Re: Village Solars Development Phase 7, Storm Water Pollution Prevention Plan Review

Electronic copy of the revised project drawings (Sheets ST-1-ST-12) dated December 7, 2022 as well as a response letter dated November 18, 2022 and email response dated December 6, 2022 were received from the Project Engineers Tim Buhl and Scott Gibson. Outstanding comments have been listed below along with the associated condition to each item per Resolution PB 22-13 dated September 12, 2022.

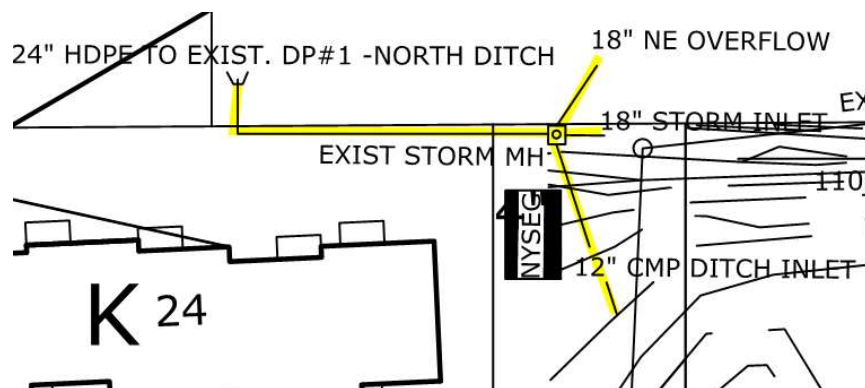
1. It is recommended that the north storm structure and associated piping that appears to have been installed by developer within ROW remain private and be identified in the SOMRA once finalized. See snip below. I would suggest the existing SOMRA be amended to include the additional storm water facilities for Phase 7. In addition I would recommend a final as-built stormwater infrastructure map be created that clearly shows stormwater infrastructure and drainage conveyance systems that are required to be maintained. SOMRA to be filed prior to signing the Notice of Termination or sooner. *Condition B prior to C/O.*
